**From:** Greeno, Jared  
**Sent:** Thursday, April 18, 2019 11:18 AM  
**To:** Bob Haines (hainesr@cityoflacrosse.org) <hainesr@cityoflacrosse.org>  
**Cc:** Lenz, Bernard <LenzB@cityoflacrosse.org>; Asp, Steve <asps@cityoflacrosse.org>; Jason Riley - City of LaCrosse (rileyj@cityoflacrosse.org) <rileyj@cityoflacrosse.org>; Odegaard, Jason <Odegaardj@cityoflacrosse.org>  
**Subject:** Sewer Lateral Connection at Memorial Pool

**From:** Haines, Robert  
**Sent:** Monday, June 24, 2019 1:35 PM  
**To:** Fran Modjeski (fran@winonamechanical.com); Brian Buelow (brian@wapashaconstruction.com)  
**Cc:** Tom Peplinski (tom@wapashaconstruction.com); Lenz, Bernard  
**Subject:** manhole inside drop

**From:** Lenz, Bernard  
**Sent:** Friday, April 12, 2019 2:07 PM  
**To:** Riley, Jason  
**Cc:** Asp, Steve  
**Subject:** FW: Dead end MH on Winnabago st that they want to connect to  
**Attachments:** Stubbed Attachments.htm

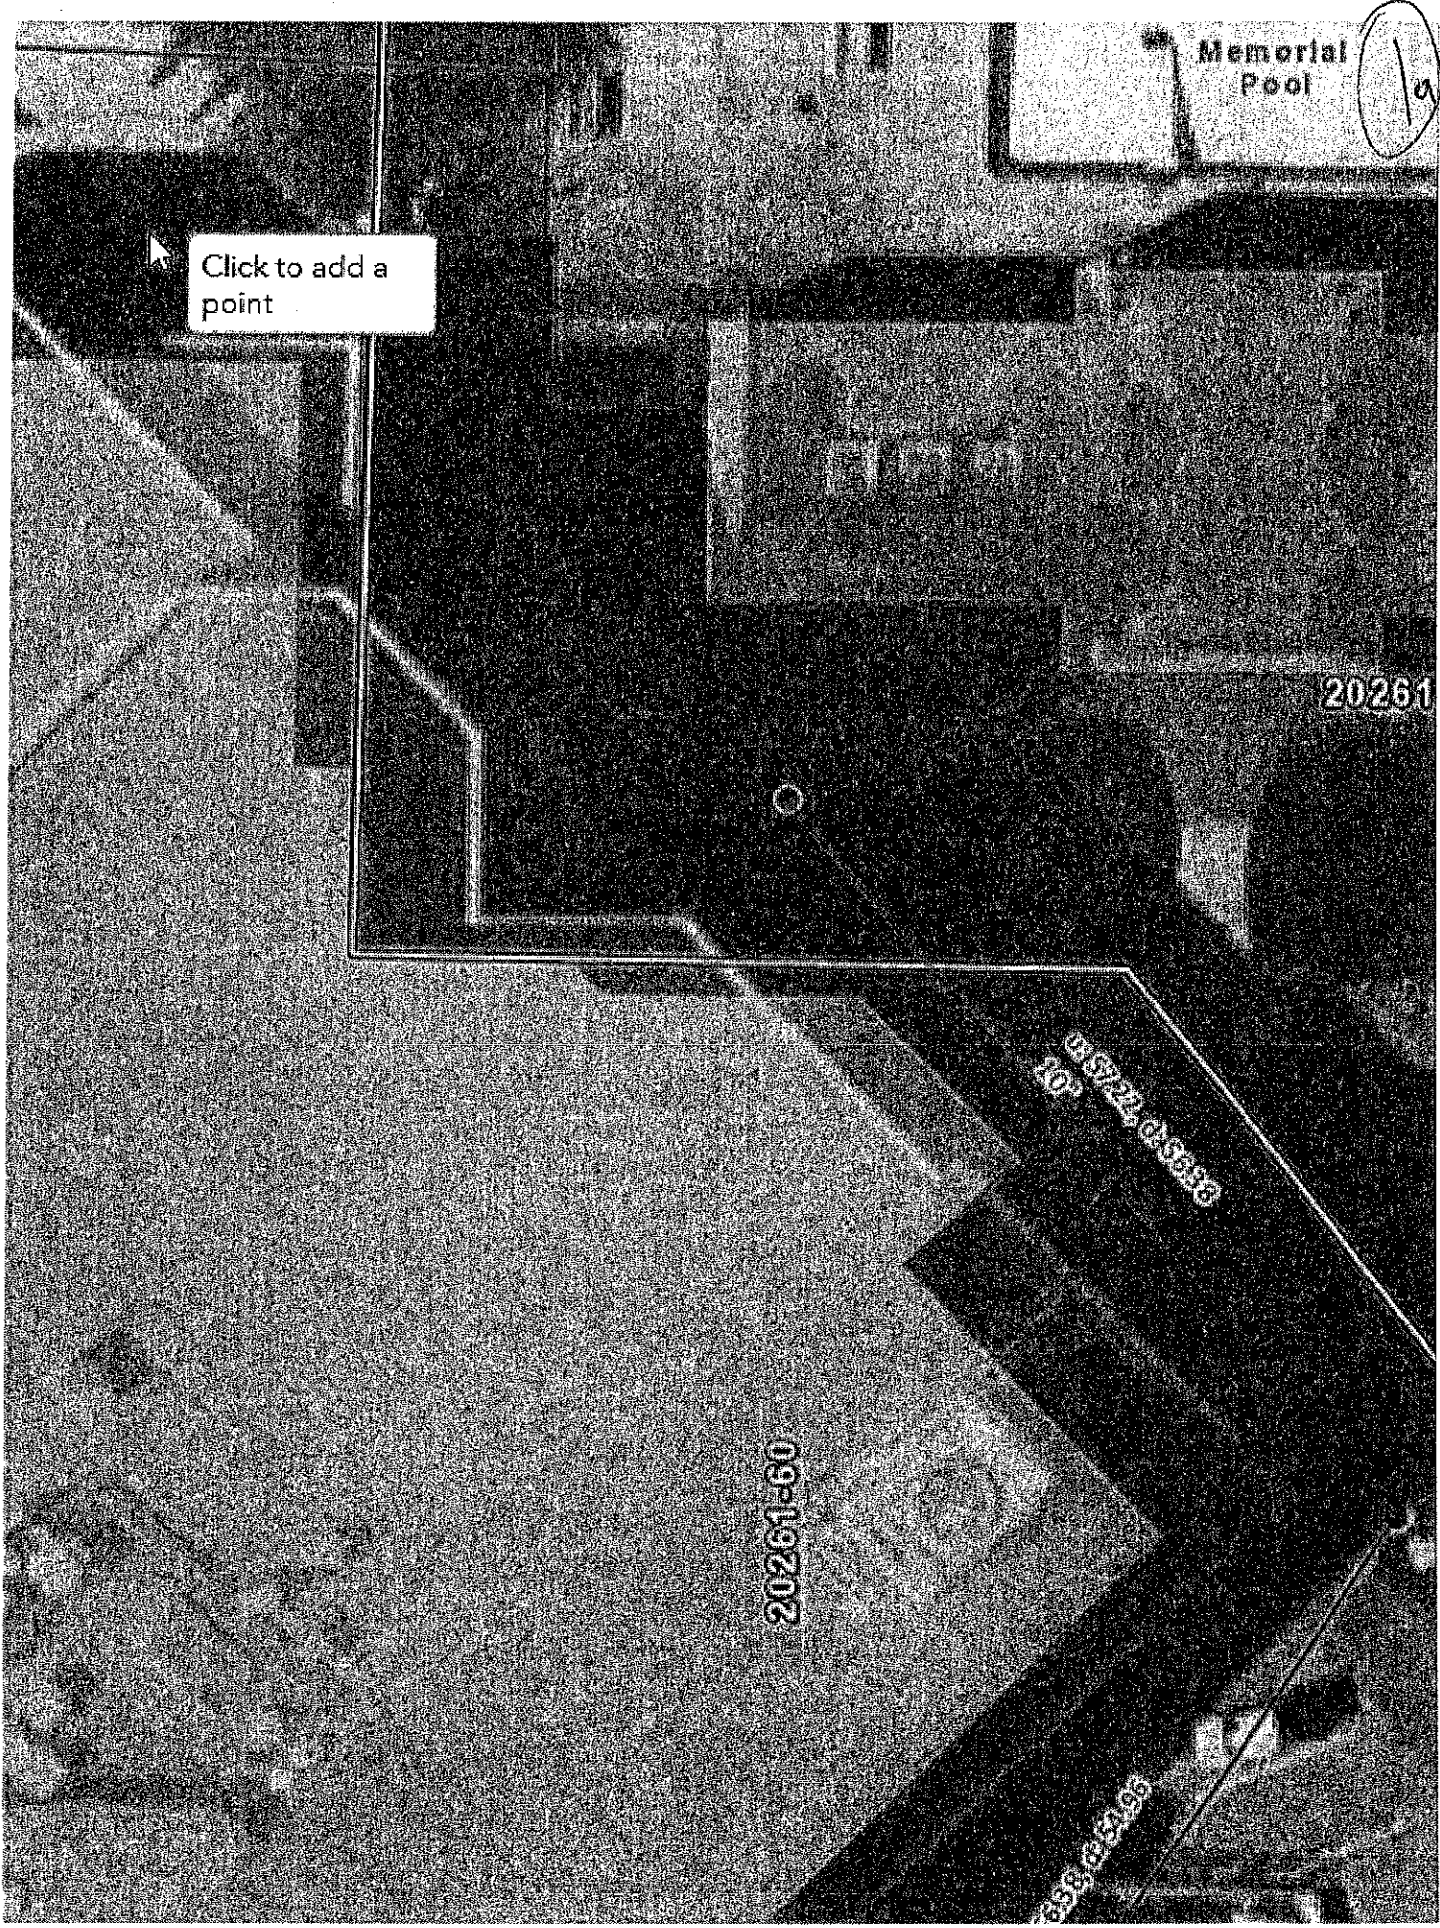
Can you make sure when the new Sewer Lateral is installed for Memorial Pool that they DO NOT install an inside drop. An inside drop makes it difficult to access the manhole for maintenance. Andy with Wiinona Mechanical called me asking if they could do that and I told him no.

Per our discussions today, this went in as an inside drop after telling both the project manager and the contractor not to do that.

Please address, fix, and let me know the results.

I hear that you connected to a manhole using an inside drop structure, which you were told was not allowable. If that is in fact correct then you need to remove it & make the connection at the manhole invert. On or about April 18 our sewer dept told Andy from Winona Mechanical that this was not allowed, and I know I mentioned it at one of our progress meetings when discussing the possible undermining of the UW-L light pole. We can certainly talk about it at our Wednesday meeting but the inside drop will not be allowed to remain.
